**Subject: Beaver Valley Power Station, Unit Nos. 1 and 2**  
**BV-1 Docket No. 50-334, License No. DPR-66**  
**BV-2 Docket No. 50-412, License No. NPF-73**  
**Responses to a Request for Additional Information in Support of License**  
**Amendment Request Nos. 317 and 190**

**REQUEST FOR ADDITIONAL INFORMATION (RAI)**  
**RELATED TO FIRSTENERGY NUCLEAR OPERATING COMPANY (FENOC)**  
**BEAVER VALLEY POWER STATION, UNIT NOS. 1 AND 2 (BVPS-1 AND 2)**  
**CONTAINMENT CONVERSION TO ATMOSPHERIC CONDITIONS**  
**DOCKET NOS. 50-334 AND 50-412**

**Figure 1: Sump water temperature history for BVPS-1 Case 6L.**

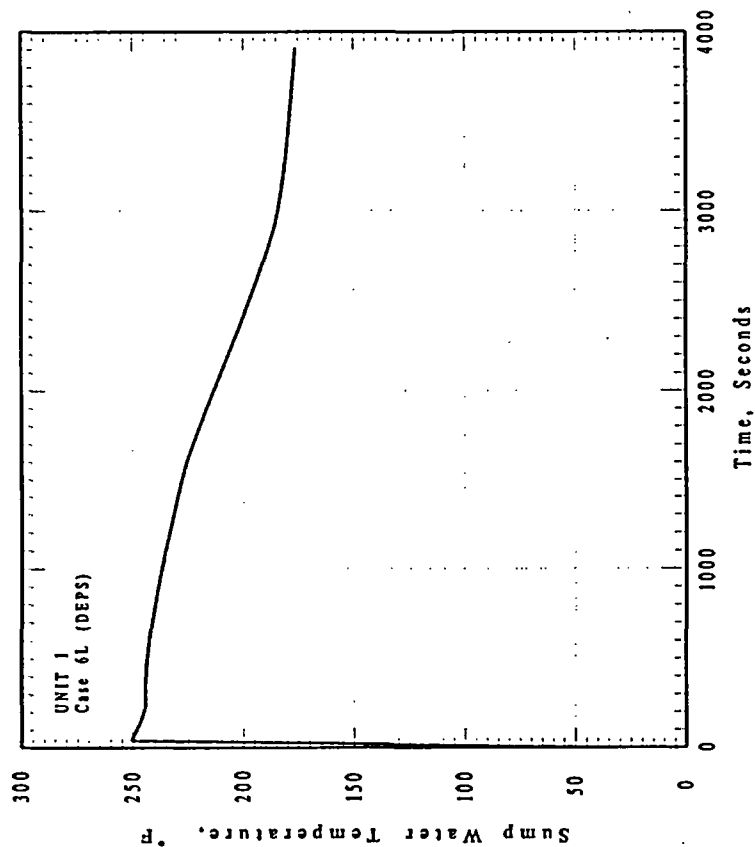
**9) sump temperature versus time**

**Figure 2: Containment pressure history for BVPS-1 Case 6L.**

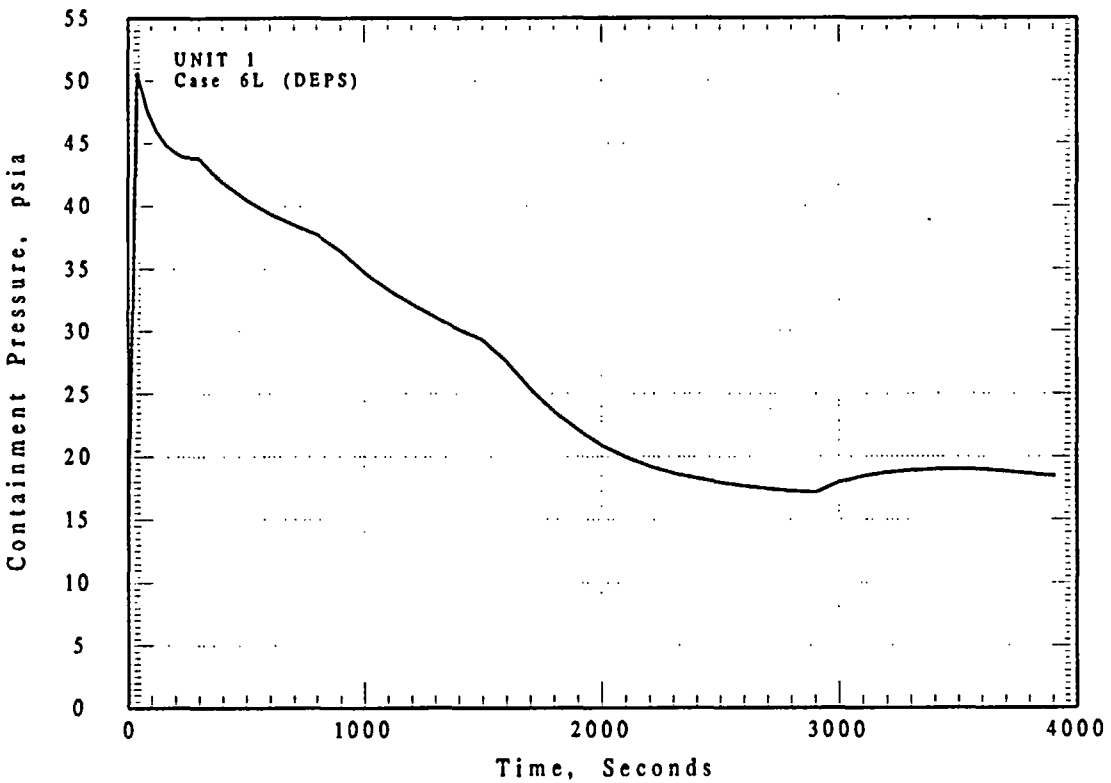
#### 14) Containment pressure as a function of time

**Figure 3: Comparison of downcomer mixture level histories for 2 and 6 inch diameter breaks.**

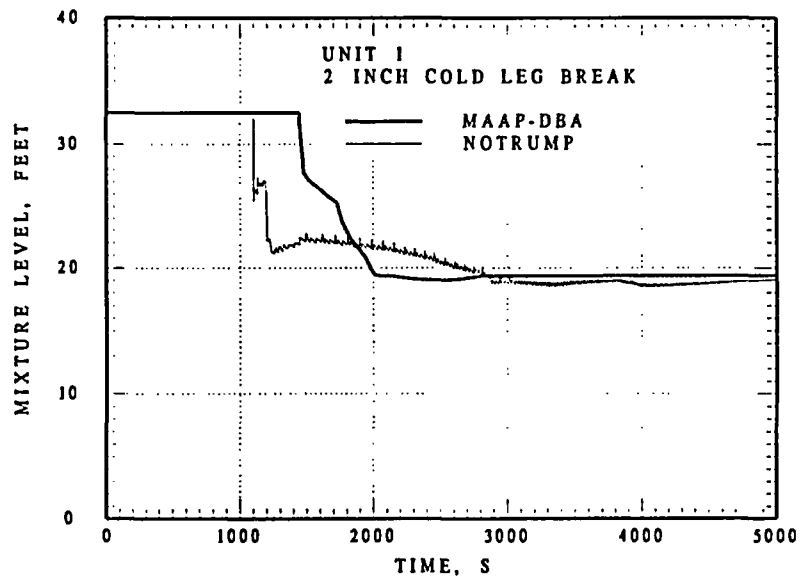
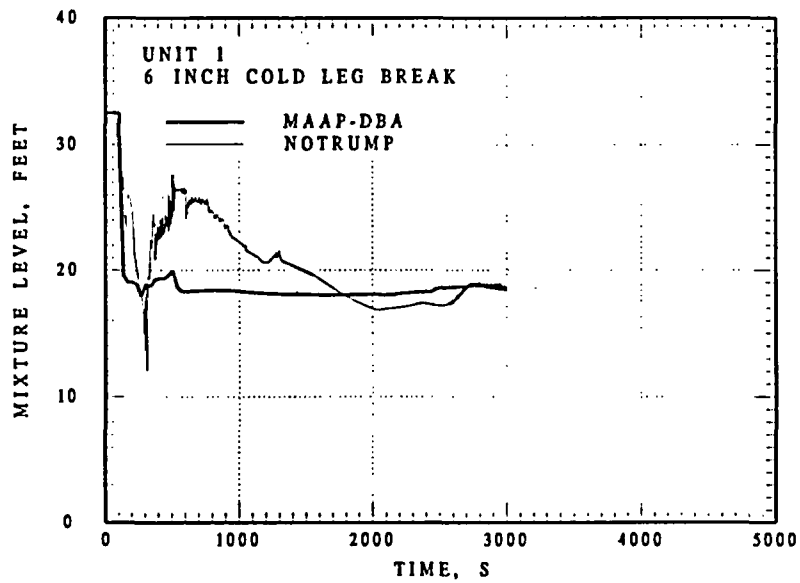
4. Response to RAI 20. Provide a Figure 2 comparing the MAAP-DBA and NOTRUMP mixture levels for a 2-inch and a 6-inch break.

Figure 3, which is a revision of RAI 20 Figure 2 (part (d)), provides the comparison of the Reactor Pressure Vessel (RPV) downcomer water levels as calculated by NOTRUMP and MAAP-DBA for 2-inch and 6-inch leg breaks. The comparison figure presents the mixture level whereas the previous RAI 20 Figure 2 presented the MAAP-DBA collapsed water level for the RPV downcomer. The level information supplements the fundamental information presented for the mass and energy benchmark in the LAR that presents the integral mass and energy release histories predicted by the two computer codes. The mass and energy release histories are the information used by the small and intermediate break LOCA containment analyses.

Figure 5: BVPS-2 containment gas temperature -comparison of design basis and sensitivity study.

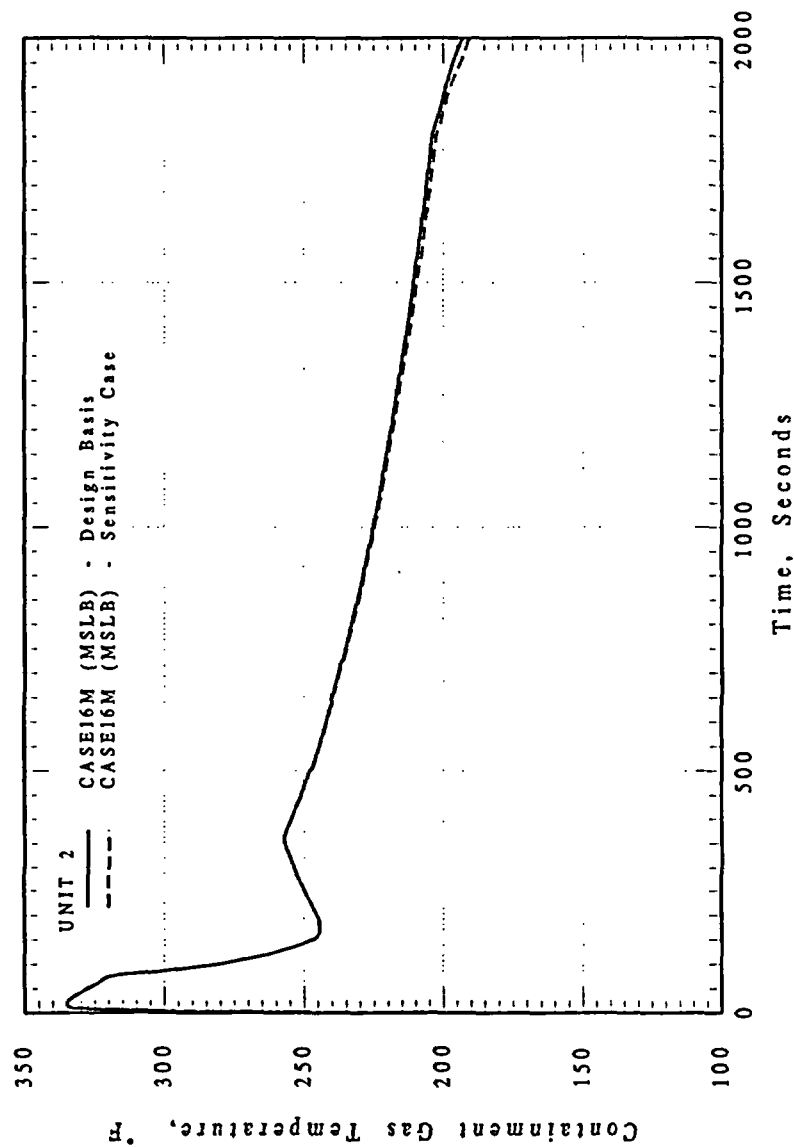
**7. Response to RAI 26: Provide results of a sensitivity of containment peak pressure and temperature to the model of the energy exchange between the water on the containment floor and the containment atmosphere.**

The containment peak pressure results from large LOCA sequences. For BVPS-1 the peak pressure occurs for Case 8L (DEHL) as reported in Table 4-16 of Enclosure 2 of the LAR and for BVPS-2 the peak pressure occurs for Case 3L (DEHL) as reported in Table 4-17 of Enclosure 2 of the LAR. The containment peak temperature results from main steam line break (MSLB) sequences. For BVPS-1 the limiting temperature presented in Enclosure 2 of LAR occurs for Case 3M as reported in Figure 4-8 of Enclosure 2 of the LAR and for BVPS-2 it occurs for Case 16M as reported in Figure 4-13 of Enclosure 2 of the LAR.

The sensitivity of the results for these four sequences to this energy exchange model was investigated by running each sequence with this model turned off in the MAAP-DBA code. As expected, the peak values for these sequences are not sensitive to this heat exchange model. The containment peak pressures for the large LOCA sequences as summarized in Table 3 are seen to be unchanged when the heat exchange between the water pool and containment atmosphere is turned off. The containment gas temperature for the MSLB sequences are compared in Figures 4 and 5. The short-term temperature values are not sensitive to this heat exchange value. A small impact of this heat exchange process is displayed in the longer term.
